27.10.2020

Our Ref: 34807-002-01
Your Ref: MCUC 2020/3524/1

Information Request Response
Development Application for Material Change of Use – Retirement Village
111-119 Port Douglas Road, Port Douglas – Lot 3 on RP729991

Figure 1: Swept paths for refuse vehicle

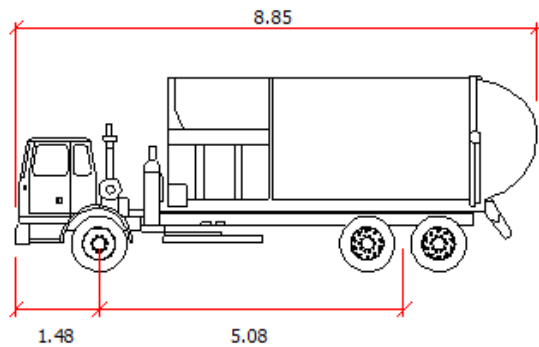
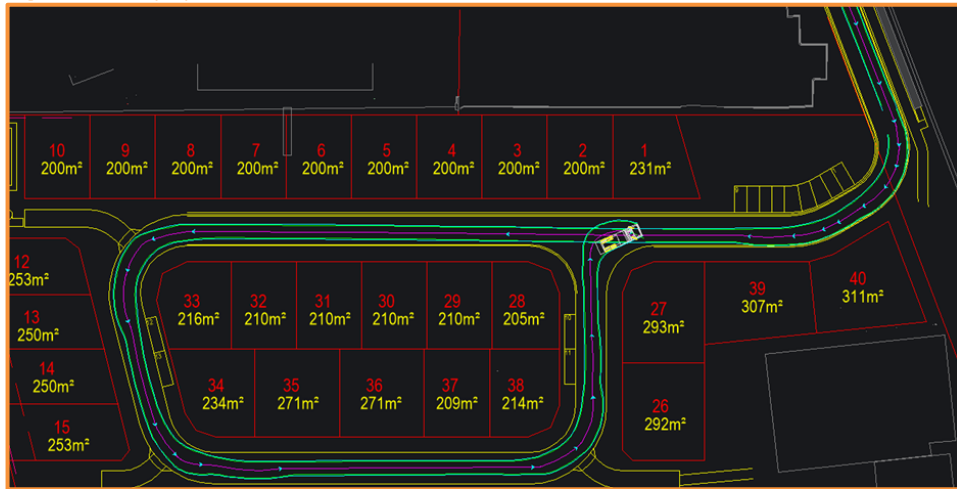
10. Demonstrate how the development will be serviced for rubbish collection. Give details of central bin storage areas if proposed and provide swept path diagrams for rubbish truck entry and egress from the site.

The applicant proposes to enter a commercial agreement with Council to allow kerbside collection within the development. The internal driveway has designed to accommodate circulation by Council waste collection vehicles as depicted in Figure 1 below.

The operator of the facility will provide Council a letter of indemnity for refuse collection within private property.

Figure 4 – LIDAR Contours Beyond Western Site Boundary

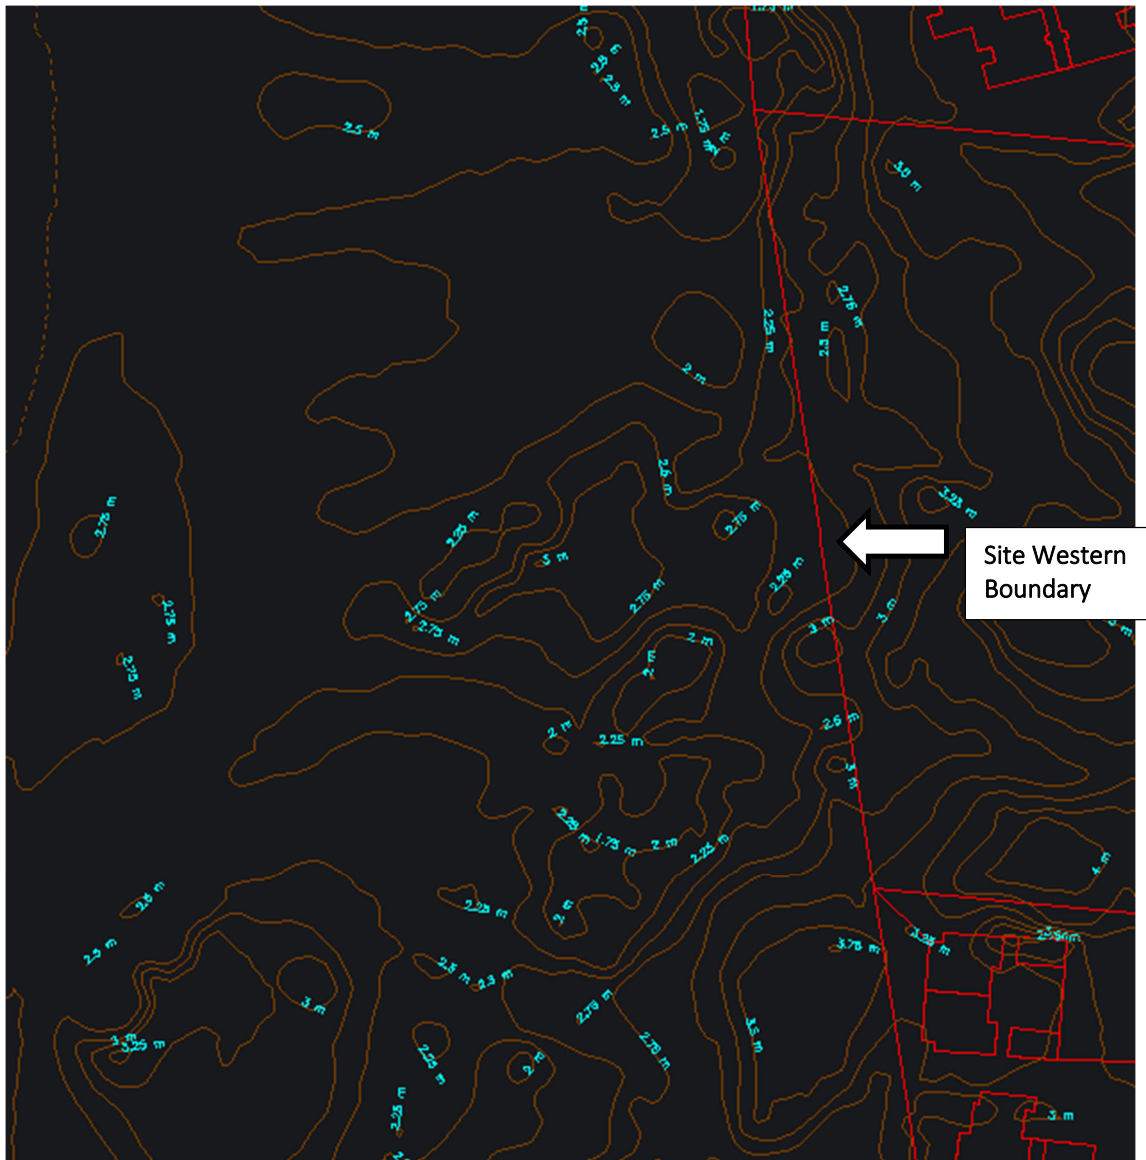
5. *Provide information on the existing and proposed levels along the western boundary (extending a minimum of 20m into the adjoining site) to demonstrate that the earthworks and filling proposed will not create ponding nuisances and/or a concentration of stormwater flows to adjoining properties;*

Provision of existing level information for 20m into the adjacent property on the western boundary to demonstrate filling will not create ponding nuisances and/or concentration of stormwater flows has been requested by Council. Figure 4 shows an image with LIDAR contours that have been downloaded from the ANZLIC Committee on Surveying and Mapping website (<https://elevation.fsd.org.au/>). The contours demonstrate that the existing surface continues to fall away from the western site boundary. It is therefore considered the works will not cause ponding nuisances or concentration of stormwater flows.

DRAWING NO. **188-002-SK03** REVISION **8**

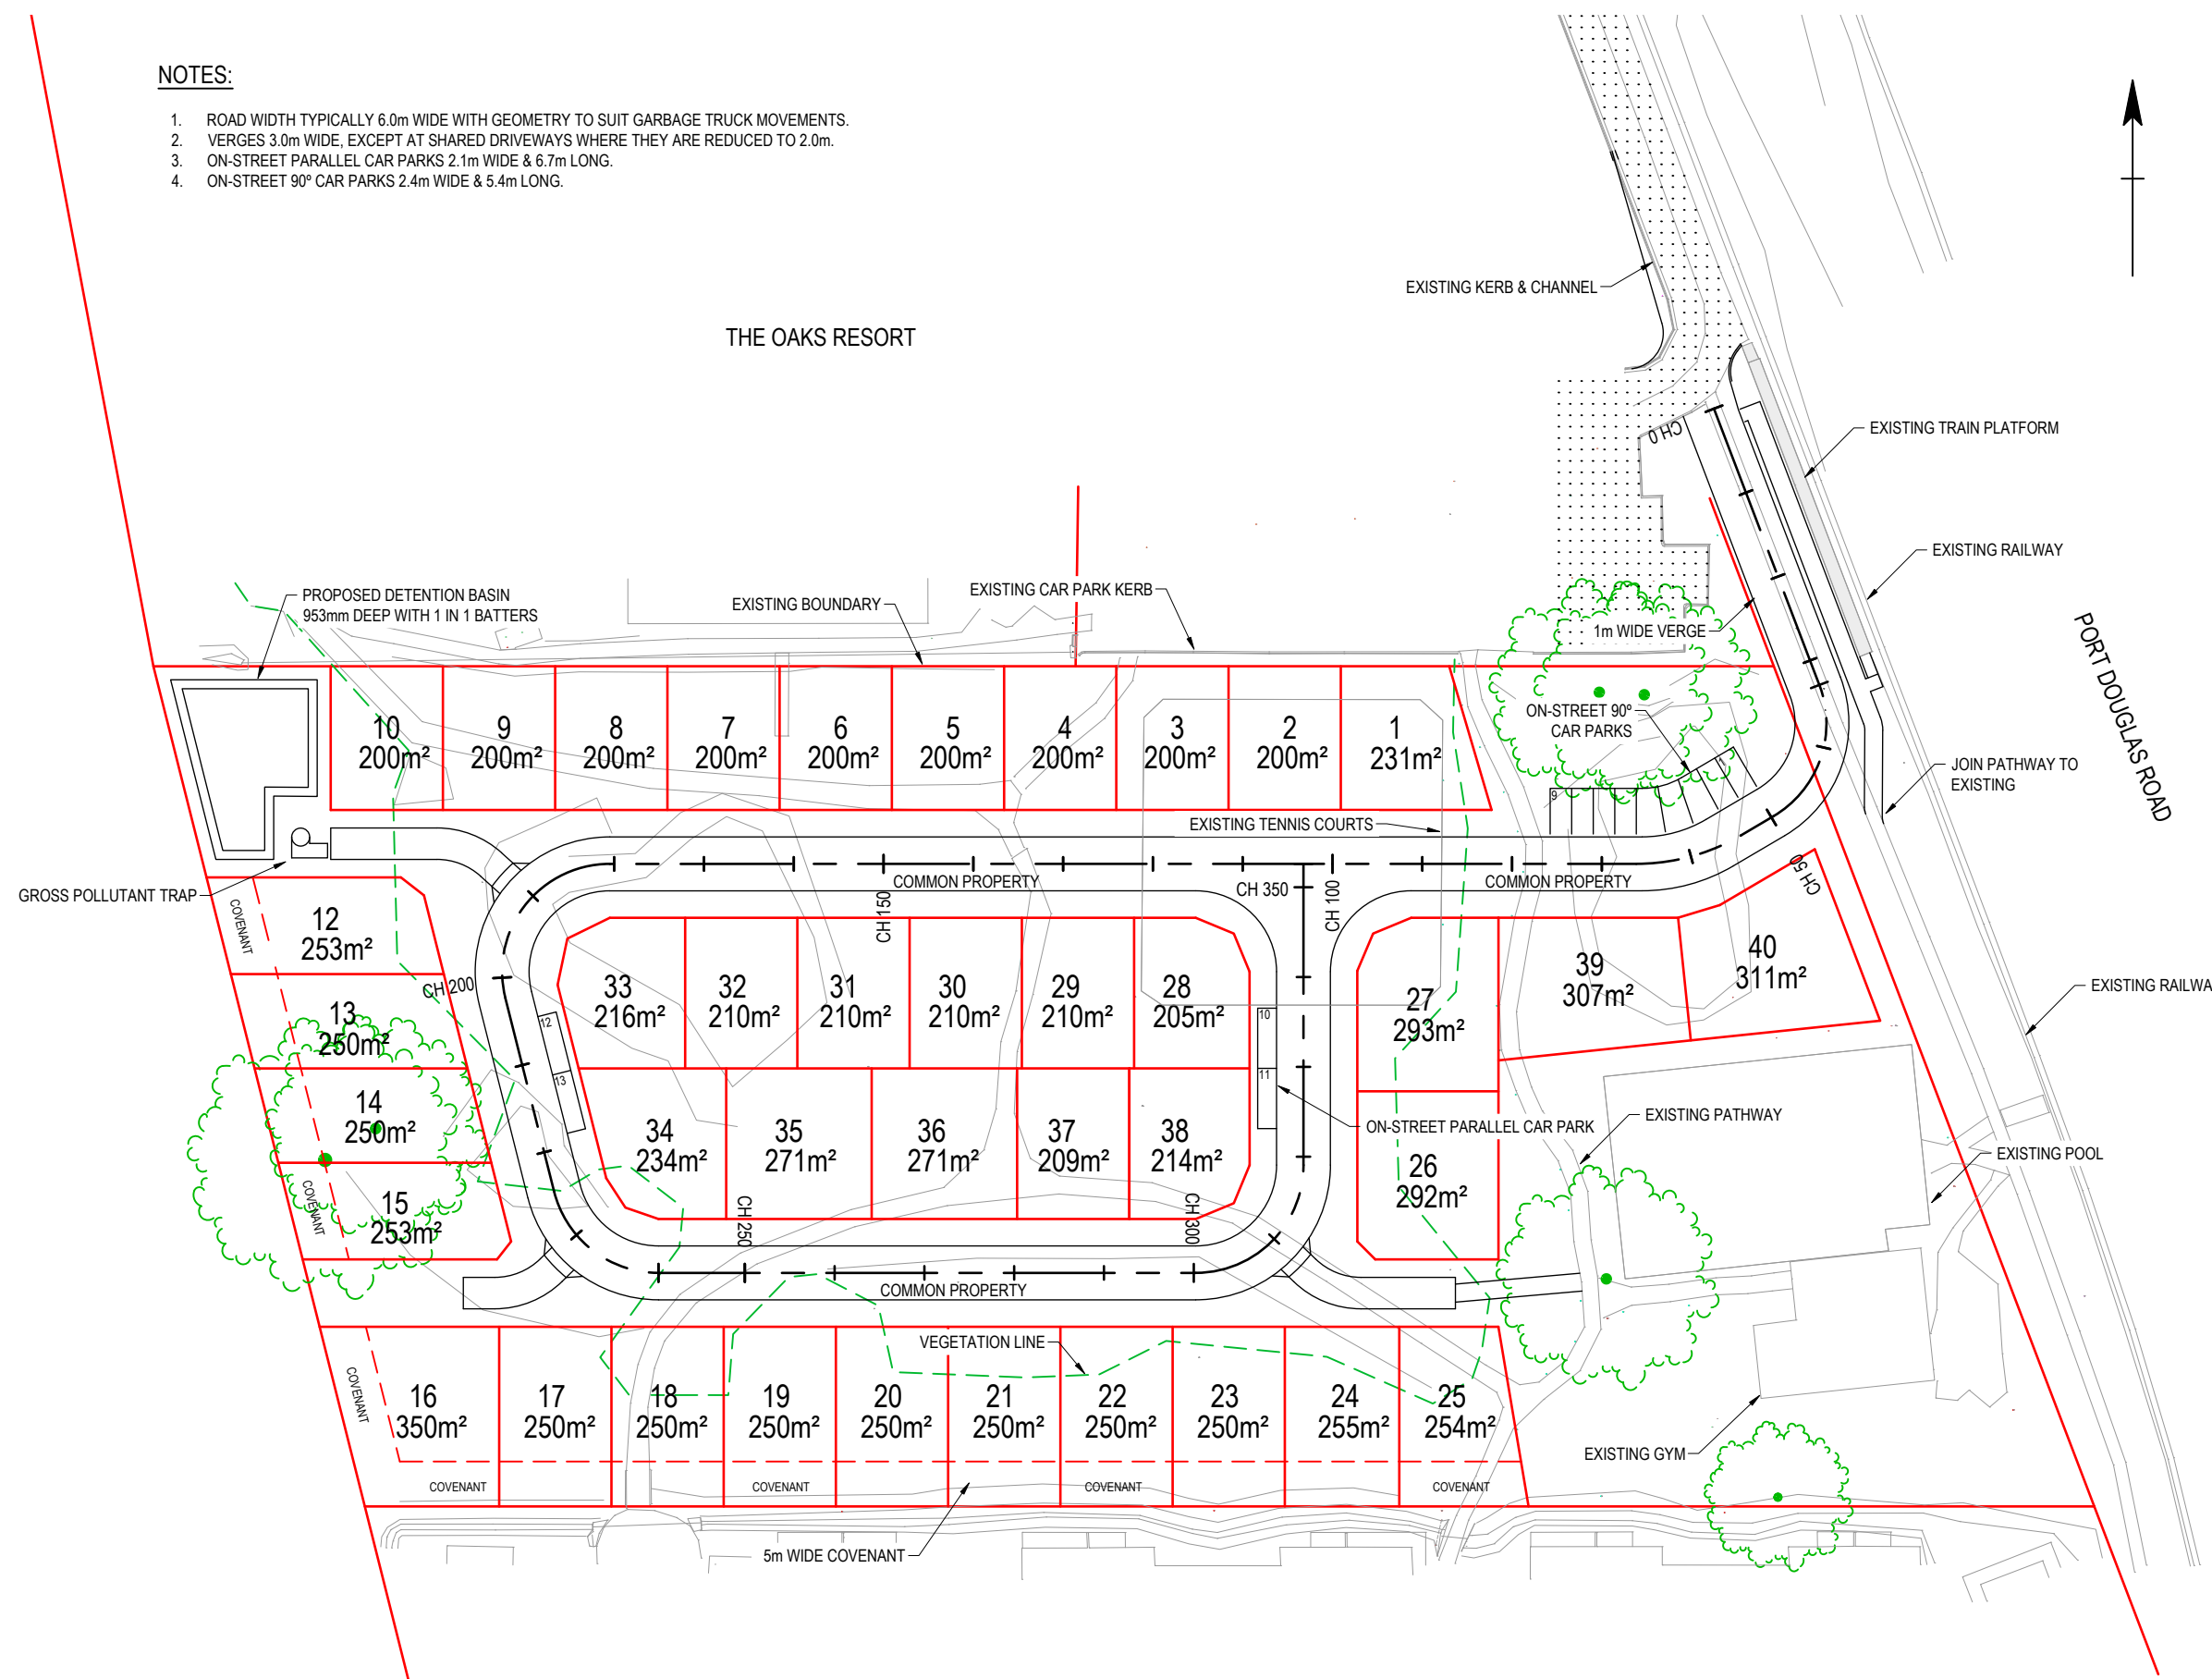
8. *Provide further information with amendments to the site plan detailing:*
 - a. *The location of the driveway for the first two houses at the frontage of the site.*

b. The orientation and/ or configuration of the second house does not appear to include a garage with practical vehicle access. Detail a practical solution.

c. For practical servicing, the central facilities building is likely to need car parking spaces adjacent to it and in close proximity to it. Provide detail of practical car parking spaces that could support this.

d. Car parking spaces 10, 11, 12 and 13 do not appear to be able to have a vehicle practically access them. Provide amendments to accommodate this.

The revised site has is included with *Attachment D*. The amendments to the site plan include:

DRAWING NO. 188-002-SK04

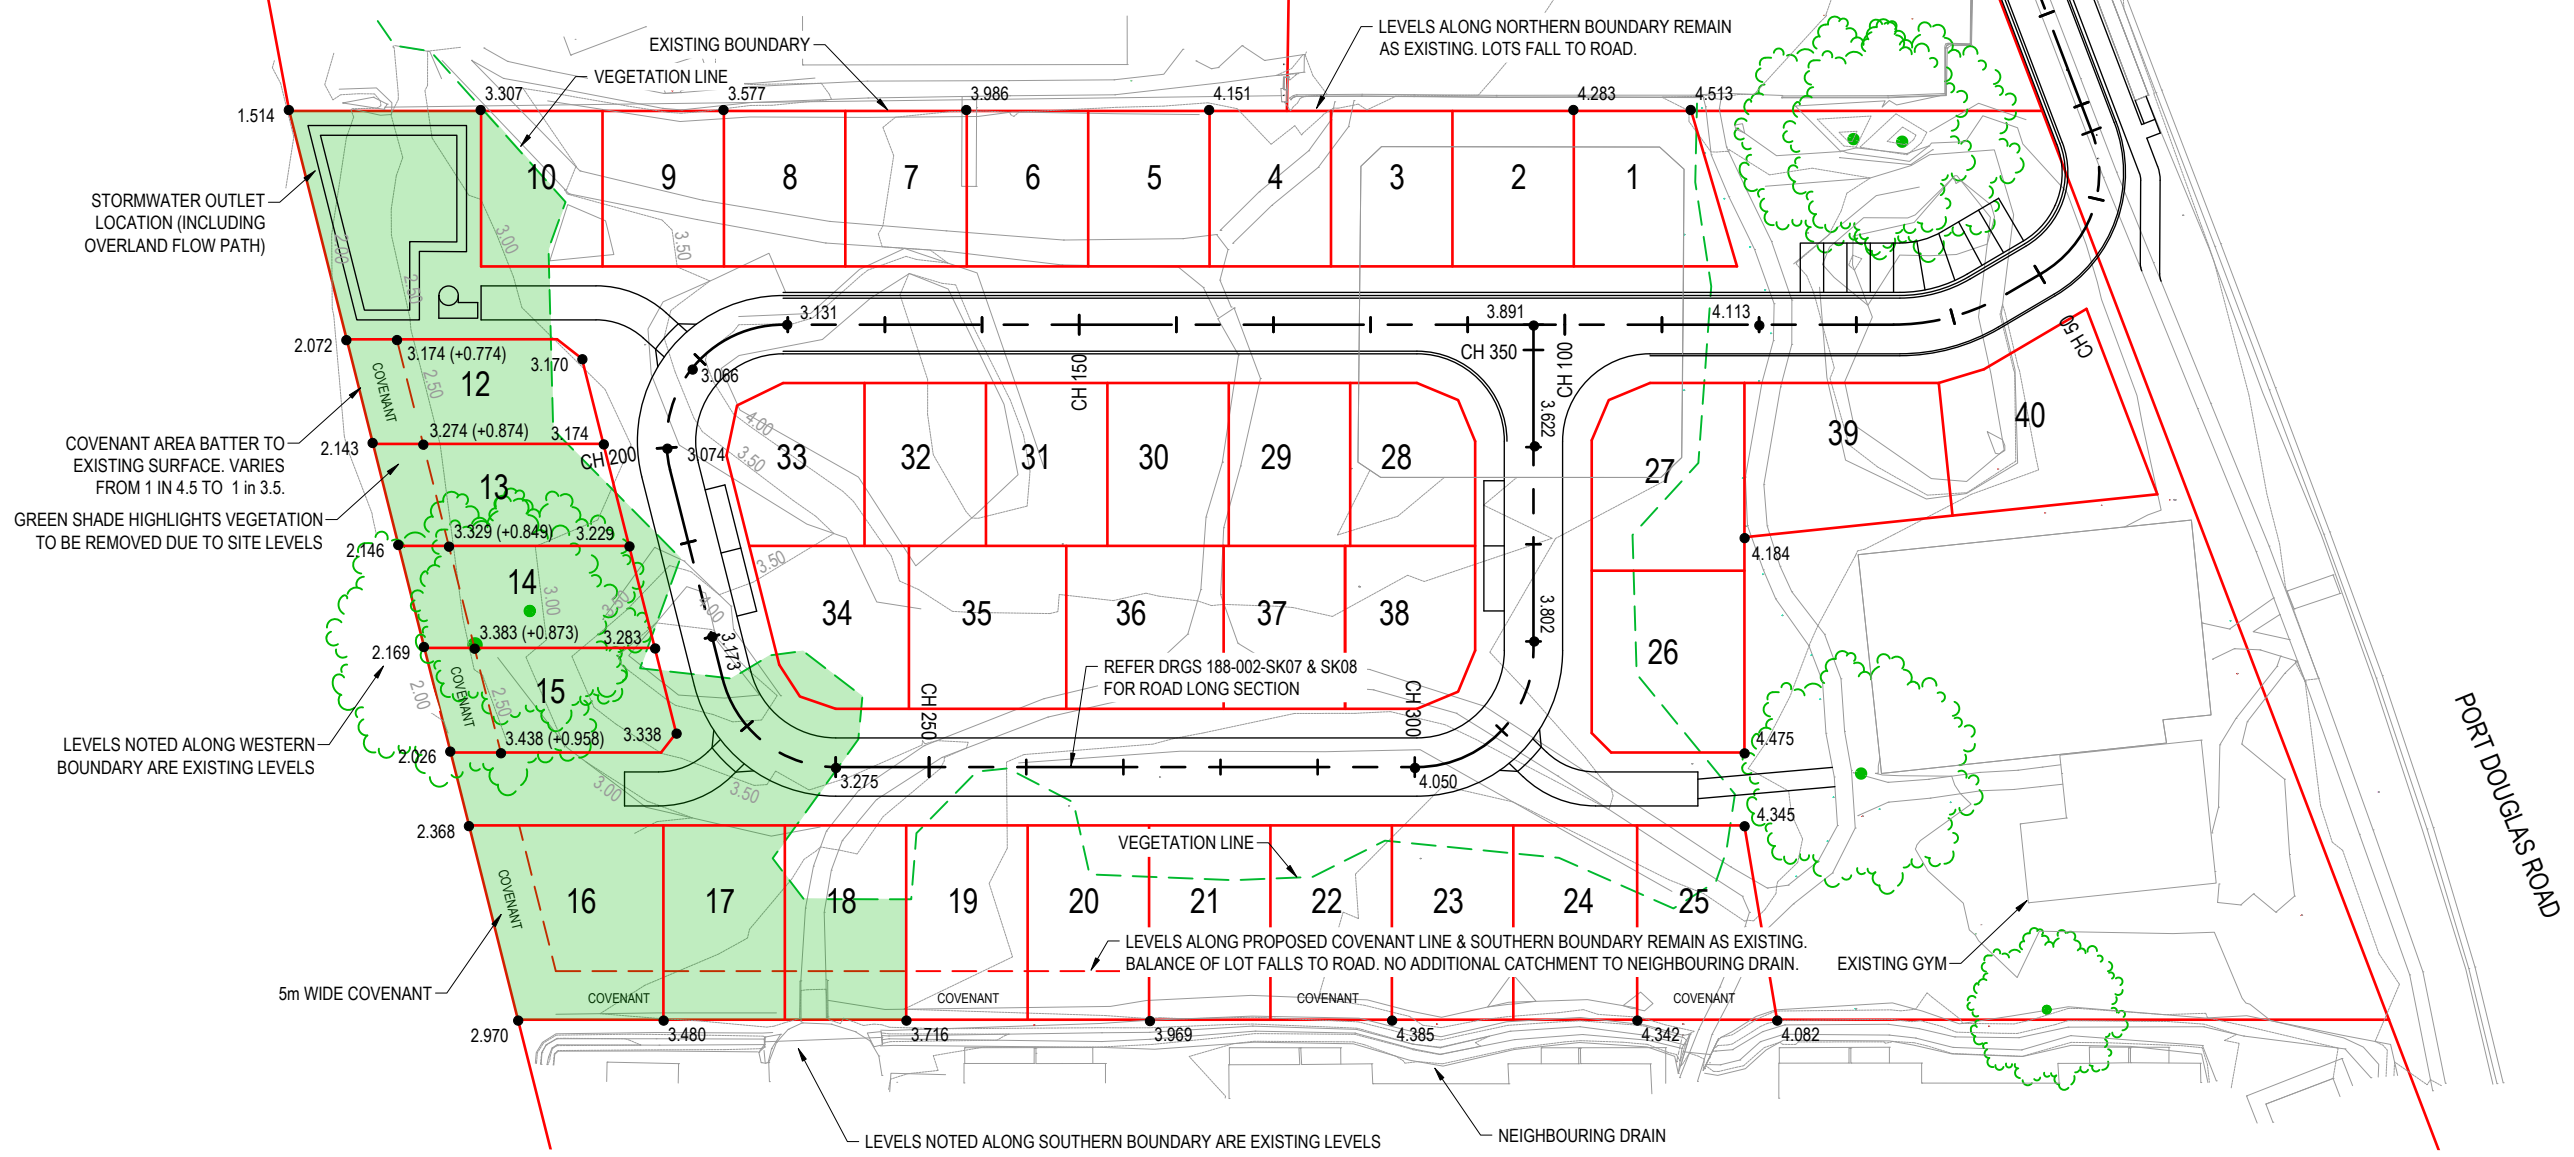
3. *Provide further detail on the proposed filling at the western edge of the allotment. In particular; batter profiles, fill heights and interface with existing ground and allotment profiles. Batter profiles must give consideration to long term stability with geotechnical advice to accompany the detail.*

Further detail has been provided on the filling at the western edge of the allotment (ie western boundary) as required by the information request. Reference is made to drawing 188-002-SK04 and the “Level Information” section above, which provide the required detail regarding batter profiles, cut / fill heights, interface with existing ground and allotment profiles.

The information request specifically requests that long term stability is considered for the batter profiles and that geotechnical advice should accompany the response. It is noted that the batter profiles range from 1 in 3.5 to 1 in 4.5 along the western boundary. FNQROC (Section D2.11 Part 8) requires that, on private land, batters should preferably be no steeper than 1 in 2 on allotments where those batters do not front a road (1 in 4 where batters do front a road). The 1 in 3.5 and 1 in 4.5 profiles meet this FNQROC requirement and therefore long-term stability is considered to have been appropriately considered. It is noted that FNQROC only requires geotechnical certification of batters that are steeper than 1 in 2 or higher than 1.5m (refer Section D2.11 Part 9). Therefore, specific geotechnical advice in this instance is not deemed warranted.
